# MONITORING YEAR 3 ANNUAL REPORT

## SHAKE RAG MITIGATION SITE

DMS Project No. 100018

RE: Draft MY3 Report Review  
Shake Rag Mitigation Site, Madison County  
French Broad River Basin: 06010105  
DMS Project ID No. 100018  
DEQ Contract #7190

- CG6 reinstalled at XS12 along Shake Rag Branch Reach 5 on 3/8/2022

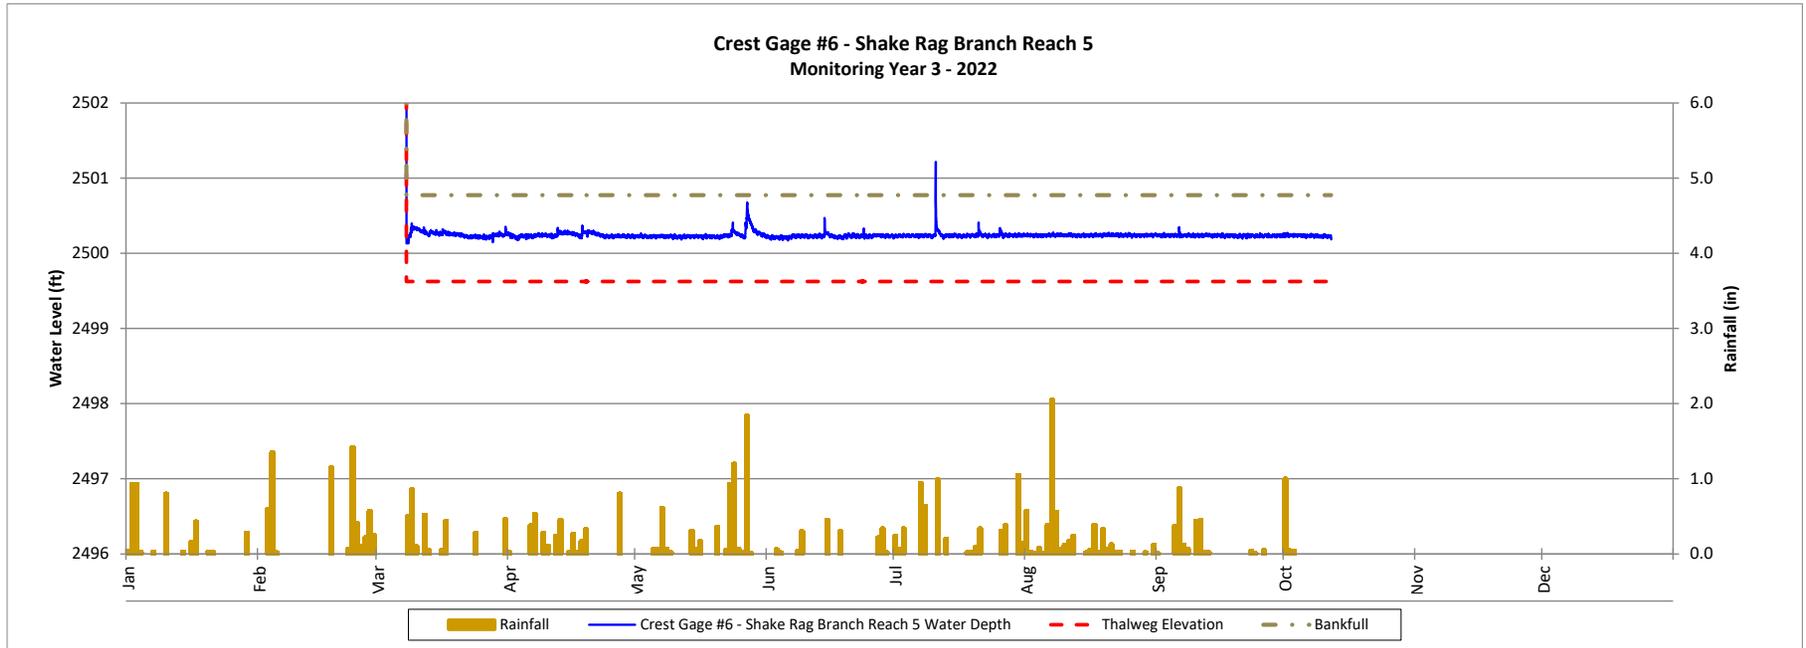
**CG3 was relocated downstream approximately 15'; however, CG6 was relocated approximately 1,300' downstream from SRB R3 to SRB R5. Please provide a discussion regarding why this gauge was moved so far from the original location. At the 2022 Credit Release Meeting, DWR had questions regarding the location of CG6. WEI discussed relocating CG6 to better represent bankfull events because it was not installed in channel and only captured flow during bankfull events; however, location was not discussed.**

*Wildlands' response: The channel slope on SRB Reach 3 is 13.4% where CG6 was originally installed was proving difficult to capture bankfull events due to the flashy nature of this Rosgen A4a+/B4a type channel. The performance standard and the monitoring components from the final mitigation plan summarized in Table 5a indicates that only one crest gage is required for all restoration/EI reaches on SRB (Reach 3, 4, and 5). The crest gage was moved approximately 1,300' downstream where the channel slope decreases to 6.6% along SRB Reach 5, increasing the likelihood of capturing an over bank event along the SRB channel.*
